# Office Action Summary

This is the first Office Action for serial number 09/868,781, An Electrical Cabinet and a Frame therefor, filed on April 8, 2002. Claims 1-9 are pending.

Fig. 1

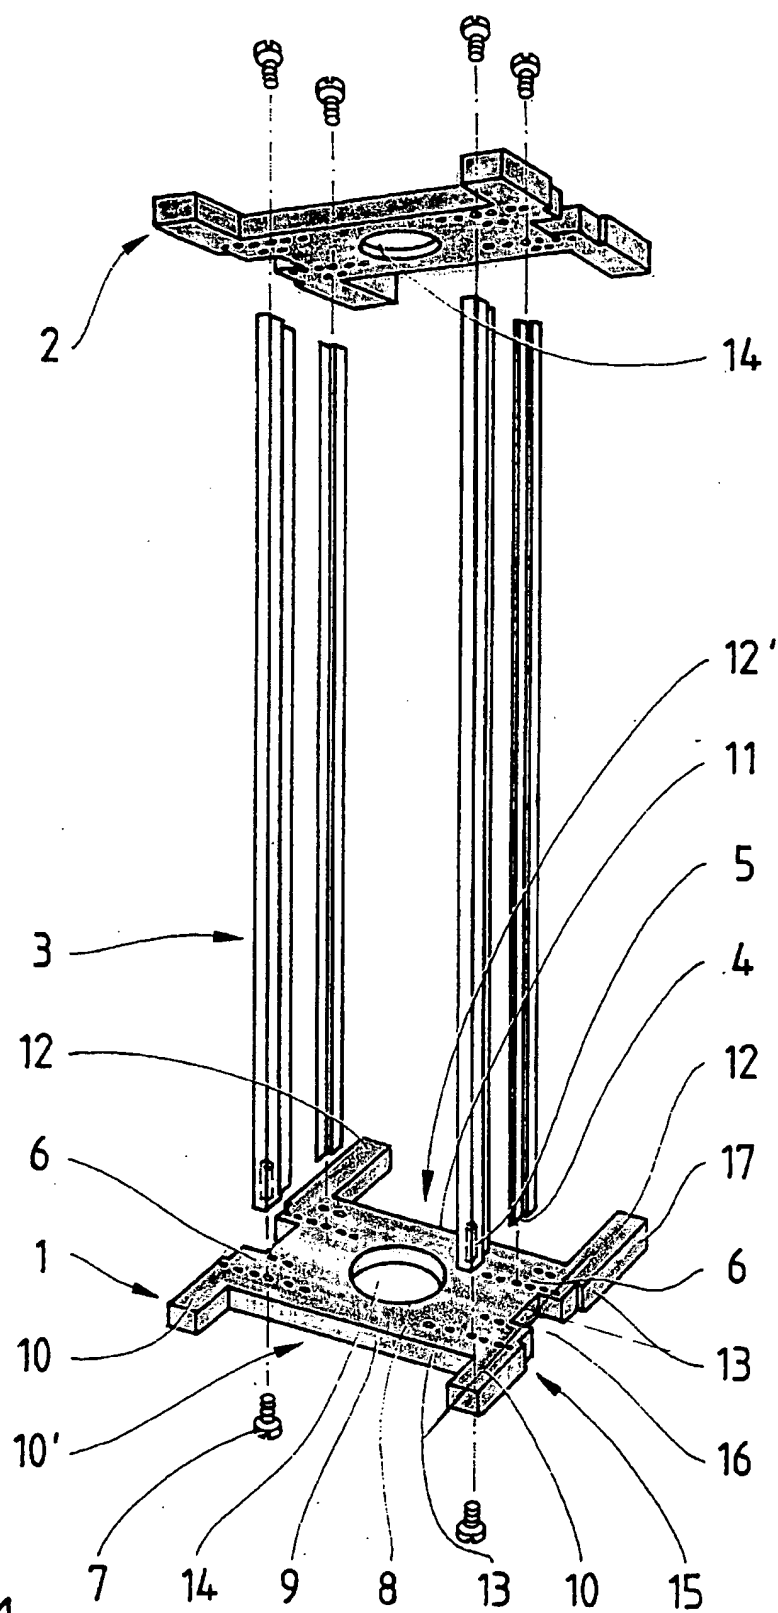
Claims 1-7 are rejected under 35 U.S.C. 103(a) as being unpatentable over U.S. Patent 5,488,543 to Mazura et al. (Mazura). With regards to claims 1 and 5-7, Mazura discloses a frame (see attached marked copy of Fig. 1) comprising: two transverse members (1,2) disposed at opposite ends of the frame and at least two side bar members (3) connecting opposed sides of the transverse members (1,2), wherein each of the transverse members (1,2) has a skeletal form formed from two connected substantially U-shaped bars (red portion, blue portion) having substantially the same shape with straight bases (at 6, at 8) and being connected together at the bases; at least one of the other sides of each of the transverse members (1,2) having a recess, and the side bar members (3) being stepped back from the other sides of the transverse members (1,2) to define a space therebetween; and further including removable side

panels (18), at least one removable door (22), and at least one removable end panel (20). Regarding claims 2-4, Mazura further teaches each of the transverse members (1,2) including two additional bars/side bar members (3) connected thereto. Mazura does not disclose the straight bases (at 6, at 8) being connected by welding or brazing. However, it would have been obvious to one of ordinary skill in the art at the time the invention was made to have formed the U-shaped bars (red portion, blue portion) as separate members joined by a weld, since it has been held that constructing a formerly integral structure in various elements involves only routine skill in the art.
